SUNDRY NOTICES AND REPORTS ON WELLS

8. Well Name and No.
FEDERAL 24 # 19. API Well No.
30-025-3318210. Field and Pool or Exploratory Area
WARREN EAST11. Country or Parish, State
LEA COUNTY, NM.

Chevron U.S.A. Inc. Wellbore Diagram : Fed 1-24

**Permanent Abandonment of Federal Wells
Conditions of Approval (LPC Habitat)**

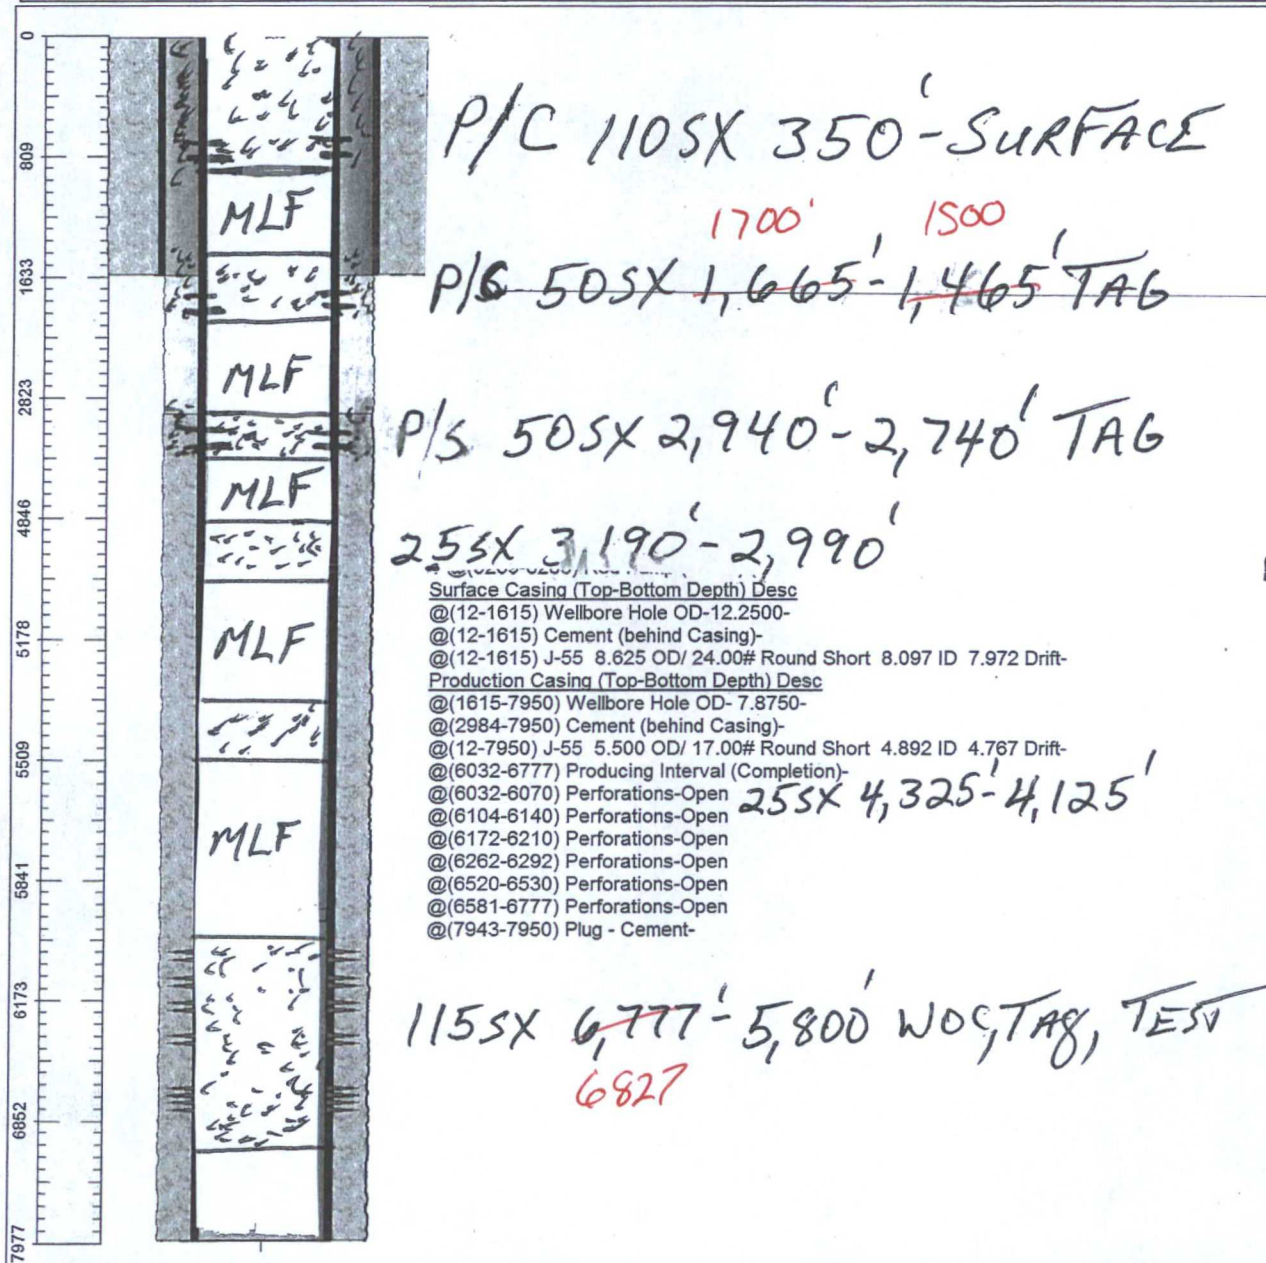
MIX & SPOT 115 SX CL "H" CMT FROM 6,777'-5,800', WOC TAG & TEST. (WARREN EAST, TUBB, BLINBRY)

MIX & SPOT 25 SX CL "H" CMT FROM 4,325'-4,125' (SAN ANDRES)

MIX & SPOT 25 SX CL "H" CMT FROM 3,190'-2,990' (SEVEN RIVERS)

PERF & SQZ 50 SX CL "C" CMT FROM 2,940'-2,740' , WOC & TAG (YATES)

PERF & CIR 50 SX CL "C" CMT FROM 1,665'-1,465' WOC & TAG (8 5/8" SHOE)

PERF & CIR 110 SX CL "C" CMT FROM 350' TO SURFACE ON BOTH STRINGS.
CUT OFF WELL HEAD 3' BGL, INSTALL REQUIRED DRY HOLE MARKER AS PER COA's, TURN OVER TO RECLAMATION.
CLASS "H & C" CEMENT USED W/ CLOSED LOOP SYSTEM.
BOND COVERAGE: CA 0329

Ground level abandonment marker RequiredSEE ATTACHED FOR
CONDITIONS OF APPROVAL
